SERVICE No. 1041 BULLETIN

Date: September 25, 2000 (S/M)

Distribution of Airborne Service Letter Number 56, "Inspection and Cleaning of Airborne Air Filter Elements"

Service Letter Number: 56

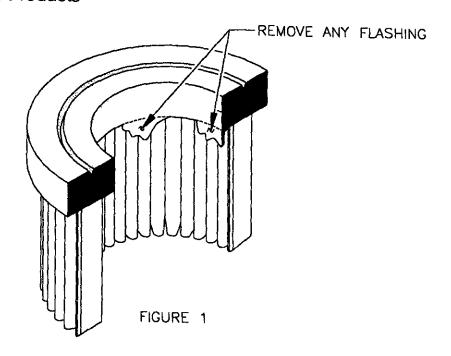
- 1) Remove the affected air filter element from aircraft per the instructions outlined in the appropriate maintenance/service manual provided by the airframe manufacturer.
- Inspect the inner diameter of the <u>black</u> end piece(s) of these elements for flashing (Figure 1). Remove all flashing using a sharp knife. <u>Caution</u>: Do not cut the paper filter portion of the element.

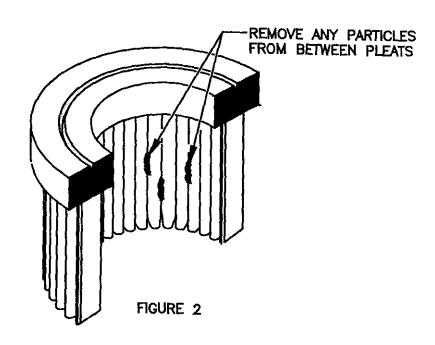
- 3) Tap the element lightly on a clean work surface in order to remove any loose particles from between the pleat tips on the inside of the paper filter (Figure 2).

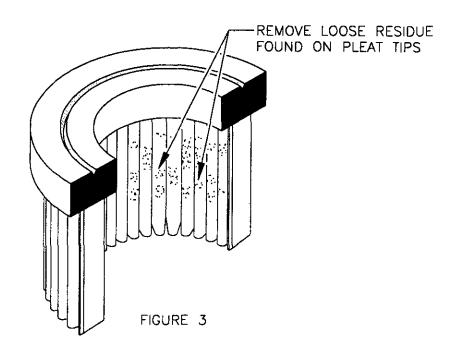
- 4) Inspect the inner diameter (pleat tips) of the paper filter for black residue (Figure 3). Remove all loose residue using the "sticky side" of a strip of masking tape attached to the end of a blunt instrument.

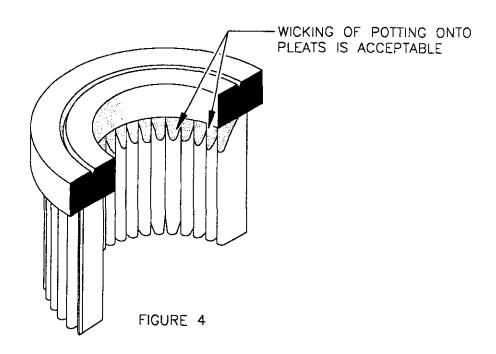
- 6) Thoroughly inspect all internal surfaces of the element for any loose particles. Remove any remaining loose particles using any combination of the above steps. <u>Note</u>: The wicking of black potting material onto pleats of paper filter is acceptable (Figure 4).
